DATE: 12.05.2018
TO: ProTrak
FROM: Mitesh Baxi
Traffic Engineering

■ **BEASLEY ROAD SUBDIVISION [Subdivision Plan Review]**

↻ Initial Review Note ↻

BASE INFORMATION:

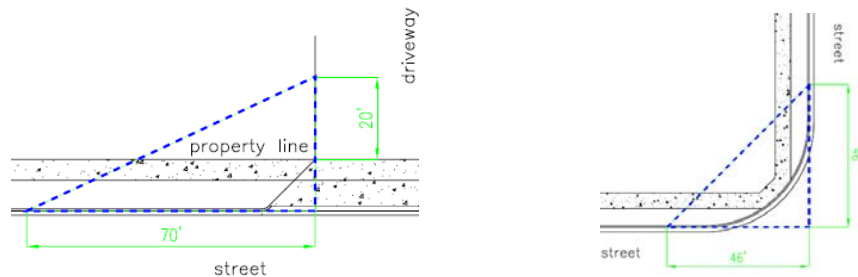
- Revise all sheets to accurately illustrate the existing conditions on and surrounding this parcel. Show all adjacent traffic signs, lane configurations, traffic control devices and pavement markings on the site inventory plan. Please refer to the Technical Standards and Specifications Manual (link is below) Ch. VII C.1.a.2. for specific information and distance requirements. Contact Traffic Engineering at 341-7888 if you need assistance locating these elements. <https://www.wilmingtonnc.gov/home/showdocument?id=1910>
- North directional arrow in the vicinity sketch is not shown accordingly.
